Subject: Response to the Nuclear Regulatory Commission's ("NRC") notice of solicitation of public comments on risk-informed changes to loss-of-coolant accident technical requirements

**MARK EDWARD LEYSE'S RESPONSES TO THE NUCLEAR REGULATORY
COMMISSION'S NOTICE OF SOLICITATION OF PUBLIC COMMENTS ON
RISK-INFORMED CHANGES TO LOSS-OF-COOLANT ACCIDENT
TECHNICAL REQUIREMENTS**

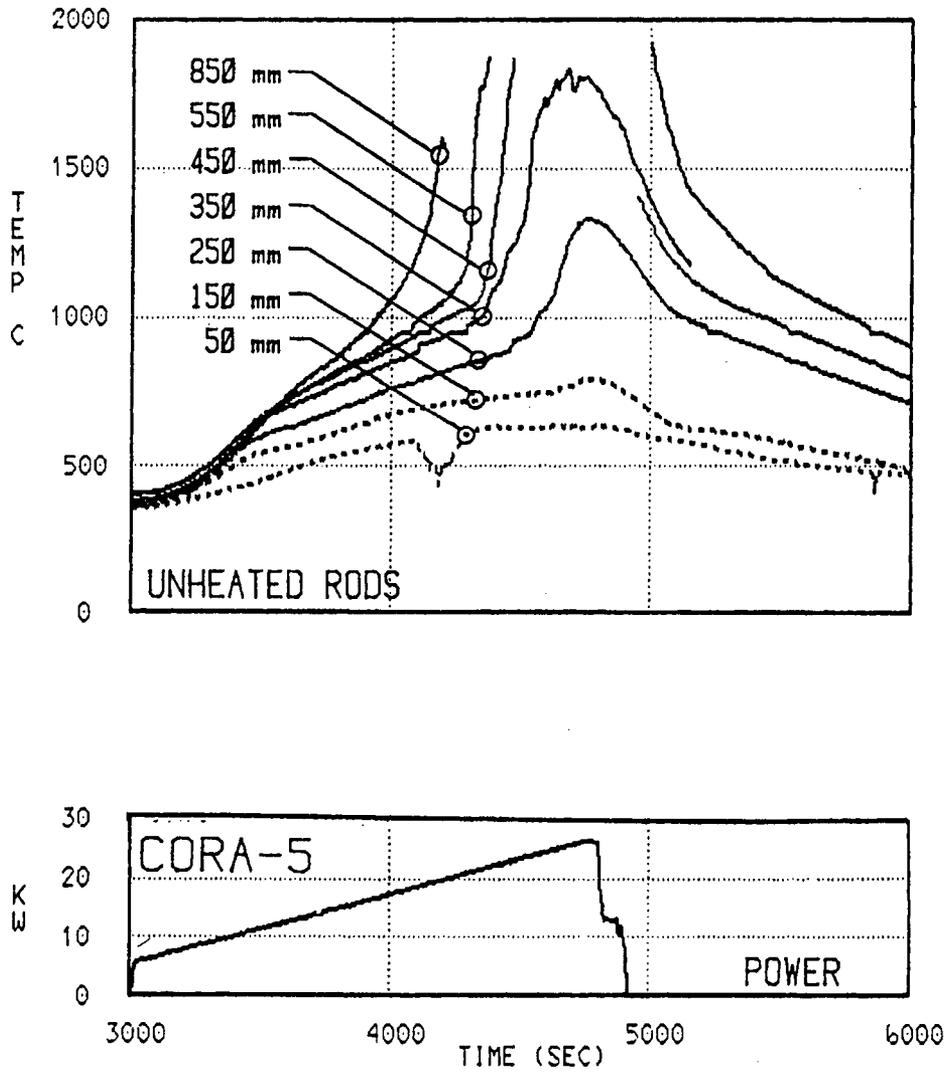
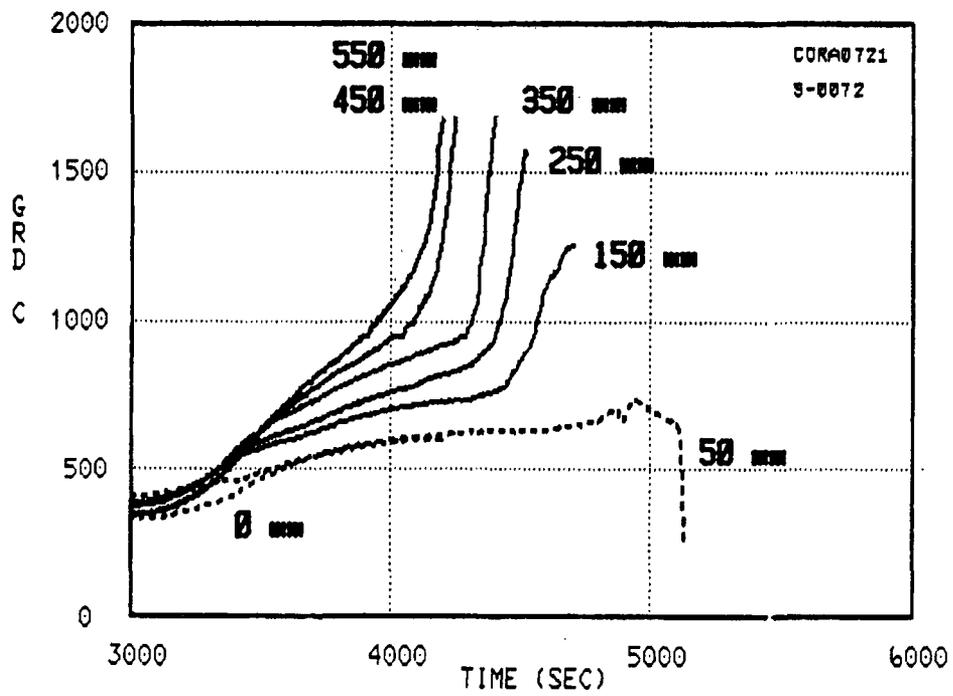
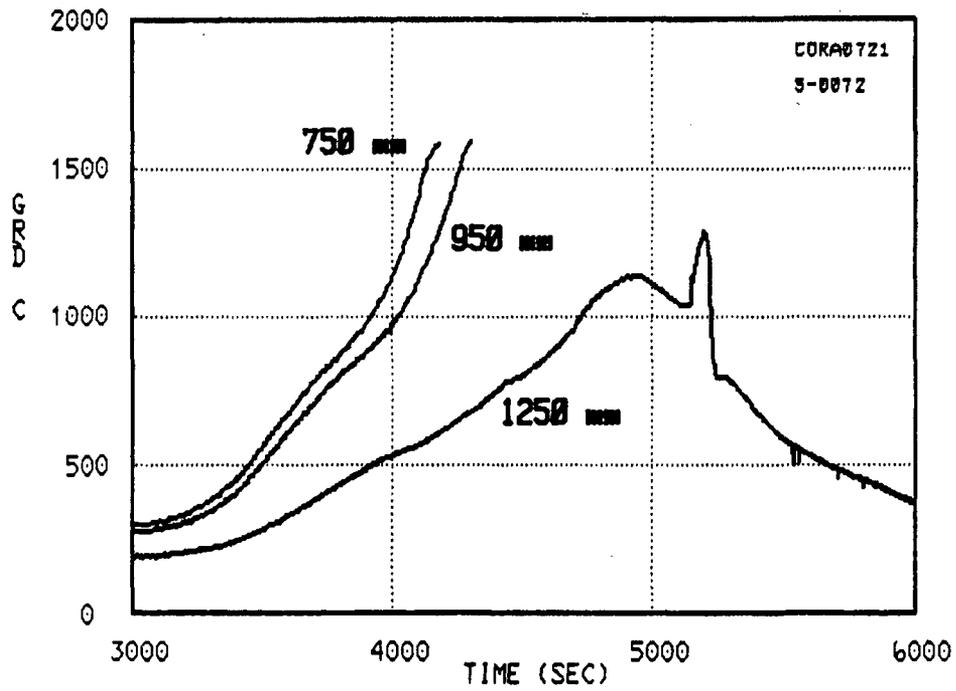
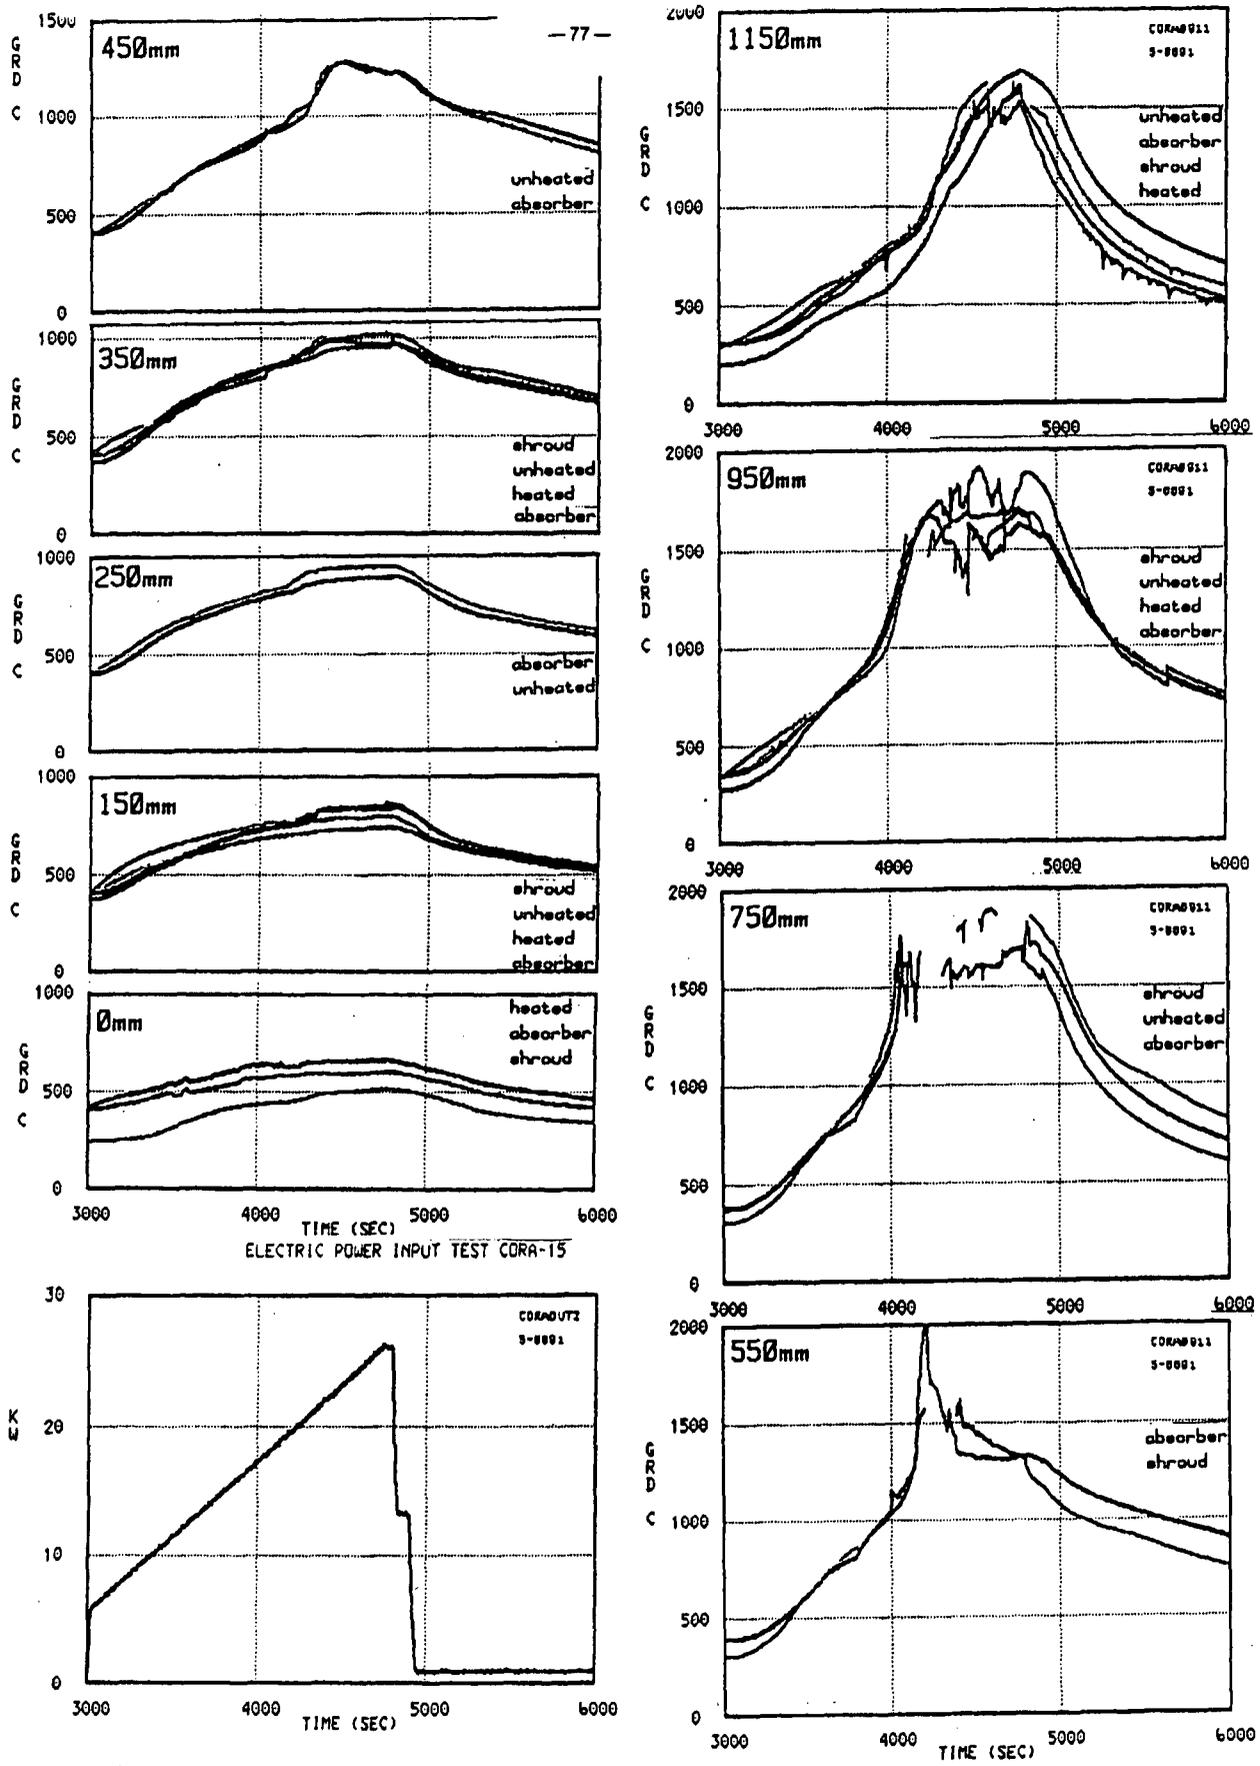
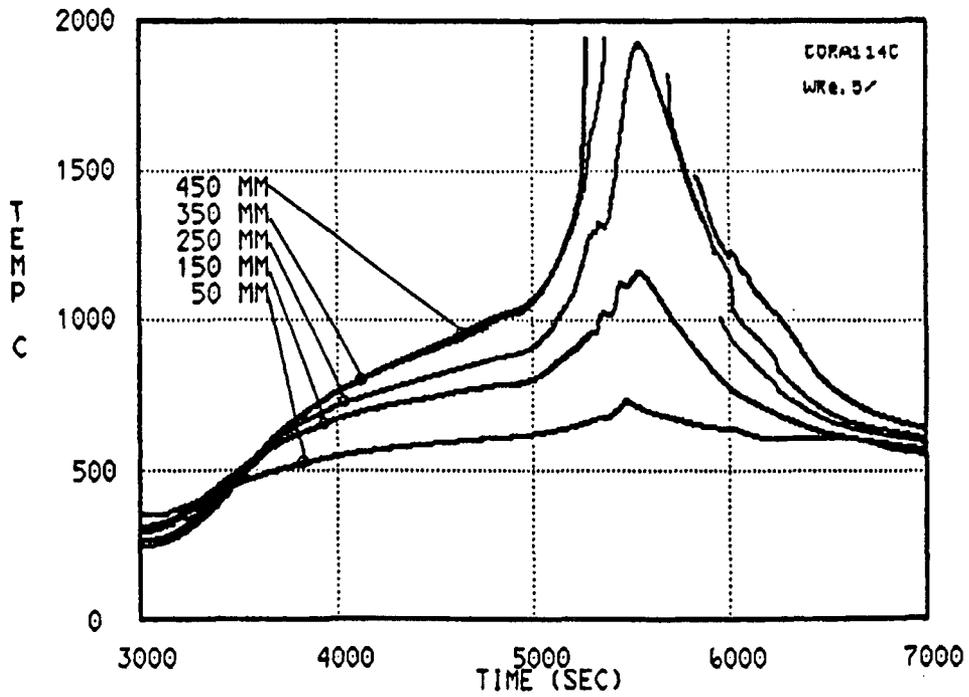
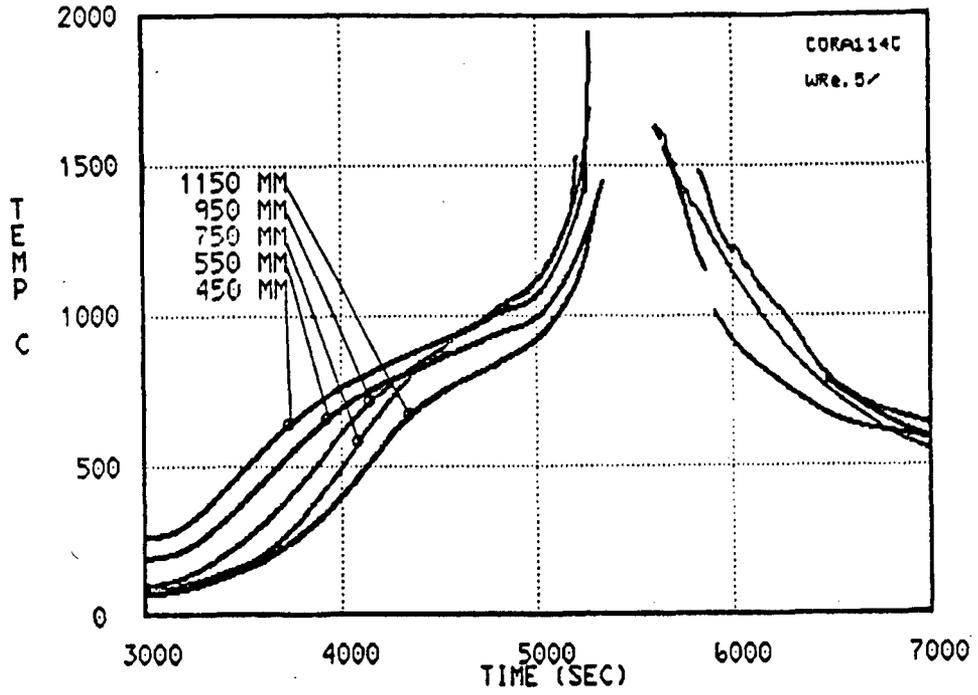
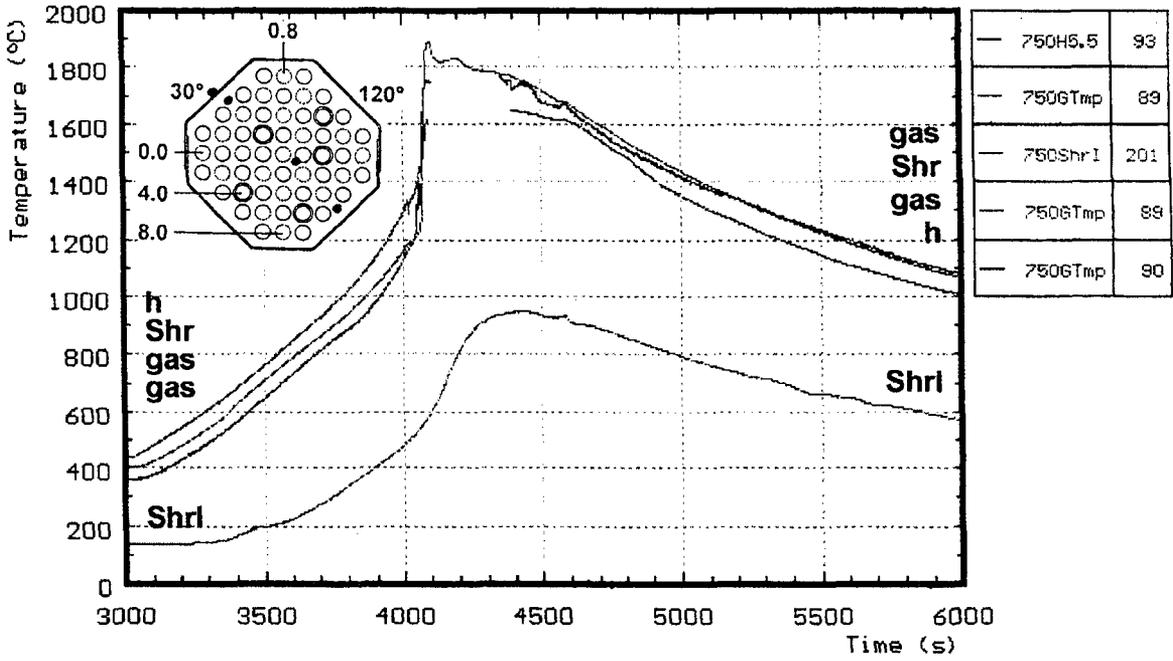
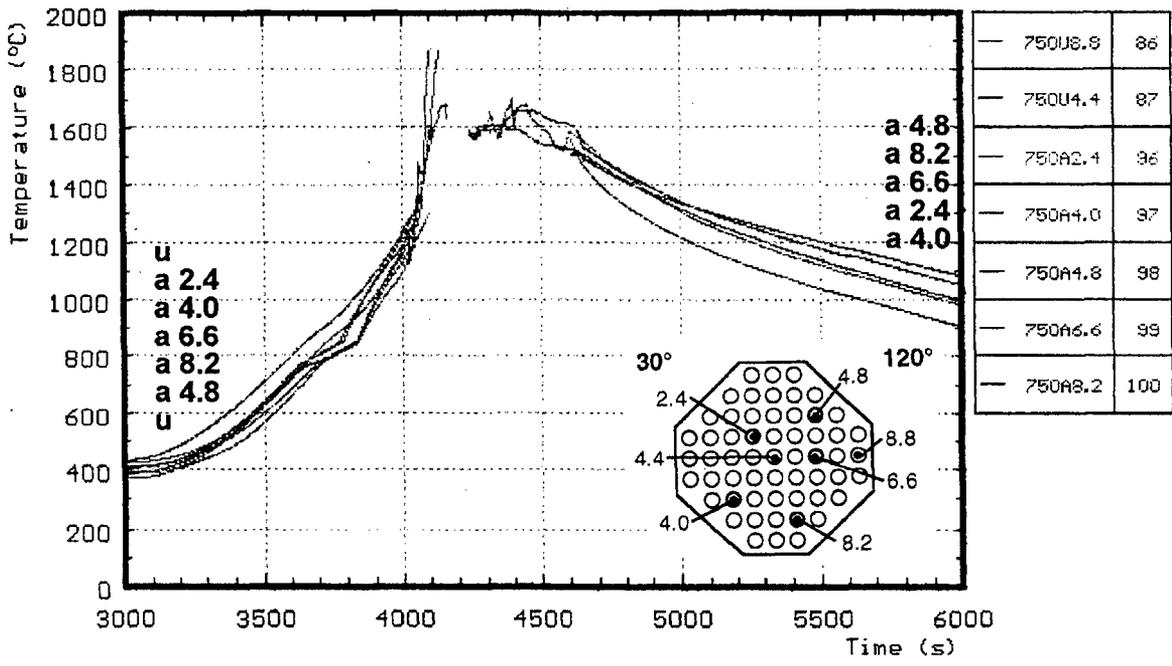
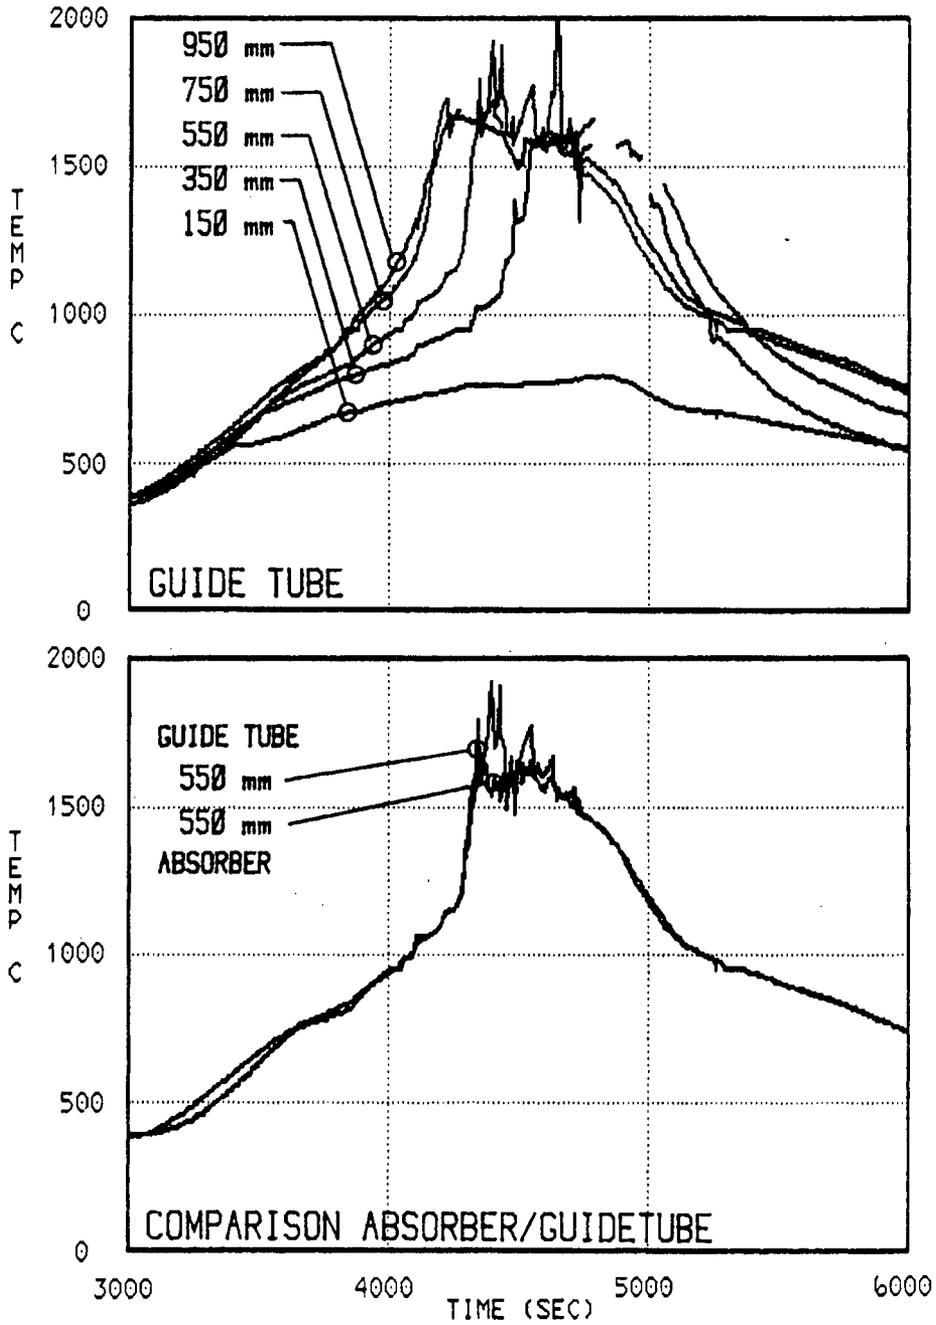
²⁴⁵ See Appendix M Figure 15 Temperatures of Unheated Rods and Power History of CORA-5, Figure 16 Temperatures of Unheated Rods during CORA-12, Figure 17 Temperatures at Different Elevations during CORA-15, Figure 18 Temperatures of Unheated Rods during CORA-9, Figure 19 CORA-7; Temperatures at Elevations Given (750 mm), and Figure 20 Temperatures of Guide Tube and Absorber Rod during Test CORA-5, which depict temperature excursions during various CORA tests; see also Appendix N Figure 37 Temperatures of the Heated Rods (CORA-13) and Figure 39 Temperatures of the Unheated Rods (CORA-13).
